# Access Compliance Report

## Public Rights-of-Way

Intersection ID: 27900	Main Street: FROHOCK_PL	Cross Street: HARRISON'S_CROSSING_AV	Location: NE
ADA ID: 238F935AD59D	Ramp Type: Perp	Initial Pass/Fail: Fail	Overall Compliance: No
		Severity Score: 25

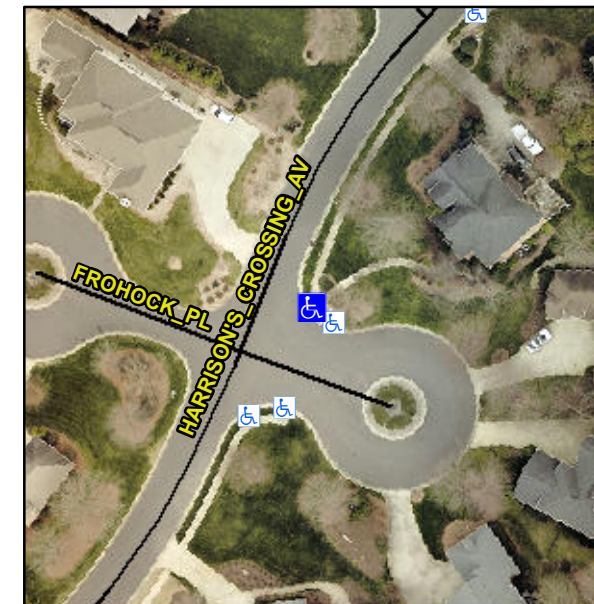
**Not Found, R304.5.3**

Compliance	Description	Data	Compliance	Description	Data
N/A	Ramp Length (in)	48.0	Yes	Ramp Slope (%)	7.6
Yes	Ramp Width (in)	48.0	No	Ramp XSlope (%)	11.1
N/A	Flare Type LT	N/A	N/A	Flare Type RT	N/A
N/A	Flare Slope LT (%)	N/A	N/A	Flare Slope RT (%)	N/A
N/A	Flare Traversable LT?	N/A	N/A	Flare Traversable RT?	N/A
N/A	Landing Length (in)	N/A	N/A	DWS Provided?	N/A
N/A	Landing Width (in)	N/A	N/A	DWS Contrast?	N/A
N/A	Landing Slope (%)	N/A	N/A	DWS Length (in)	N/A
N/A	Landing X Slope (%)	N/A	N/A	DWS Full Width?	N/A
N/A	Landing Curb? (Y/N)	N/A	N/A	DWS Offset (in)	N/A
N/A	Shared Landing?	N/A			
N/A	Gutter Ponding?	N/A	N/A	Gutter Slope (%)	N/A
N/A	Gutter Lip Ht (in)	N/A	N/A	Gutter X Slope (%)	N/A
N/A	Painted X Walk1?	No	N/A	Painted X Walk2?	N/A
	X Walk 1 Direction	To NW		X Walk 2 Direction	N/A
N/A	X Walk 1 Width (in)	N/A	N/A	X Walk 2 Width (in)	N/A
	X Walk 1 Slope (%)	6.0		X Walk 2 Slope (%)	N/A
	X Walk 1 X Slope (%)	5.0		X Walk 2 X Slope (%)	N/A

**Remove & Replace Entire Ramp.**
